Engine Oil or Coolant Leak For 1996-2003 GM 3.1 & 3.4L VIN J & E Engines

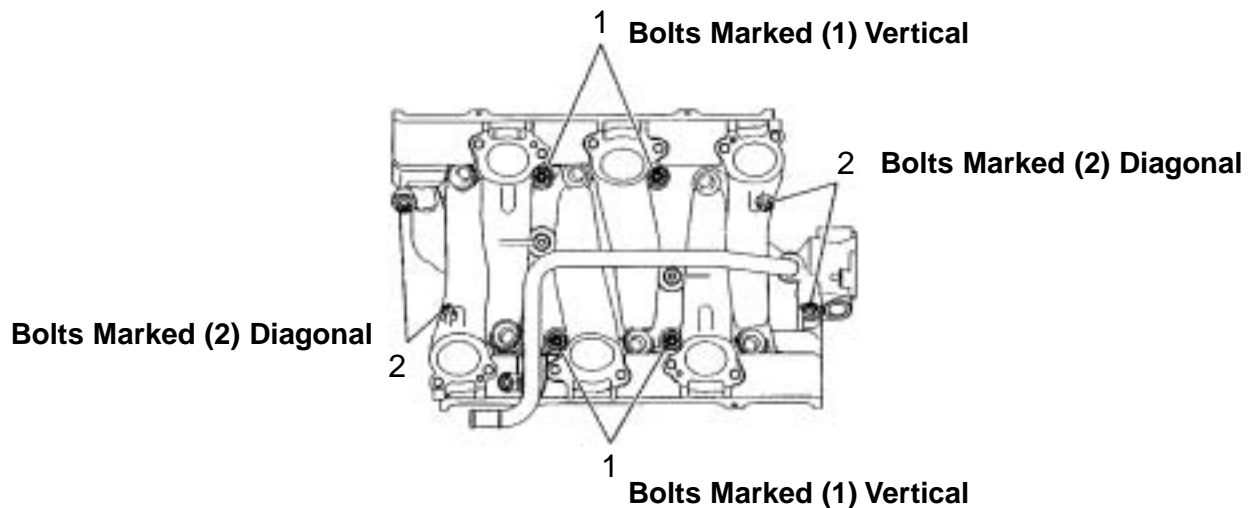
NOTICE: An oil leak may result if the vertical bolts (1) shown below are not tightened before the diagonal bolts (2). Diagonal bolts may require a crows foot tool to tighten.

1. Tighten the vertical (1) lower intake manifold bolts to 62 in/lbs. (7 N-m).
2. Tighten the diagonal (2) lower intake manifold bolts to 62 in/lbs. (7 N-m).
3. Tighten the vertical (1) lower intake manifold bolts to 115 in/lbs. (13 N-m).
4. Tighten the diagonal (2) lower intake manifold bolts to 18 ft/lbs. (25 N-m).
